**ADDENDUM #002**

**TO THE BID FOR: B025-40 Supply and Install Chiller at Washington Middle School**

**FOR: City of Meriden**

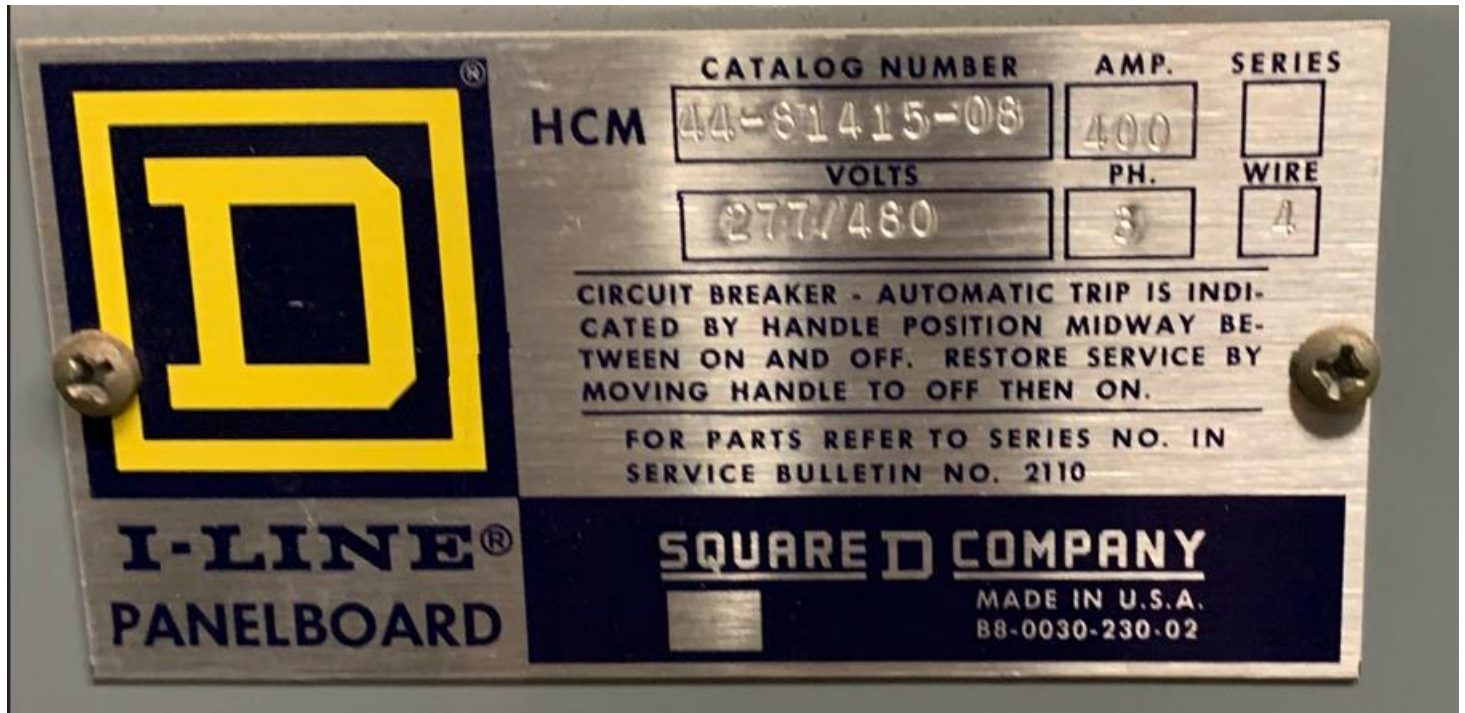
**Question:** Please clarify the seismic section on the specifications, would it be required for the chiller/pump.

**Answer:** Seismic protection is not required. Specifications Section 23 05 48 may be omitted.
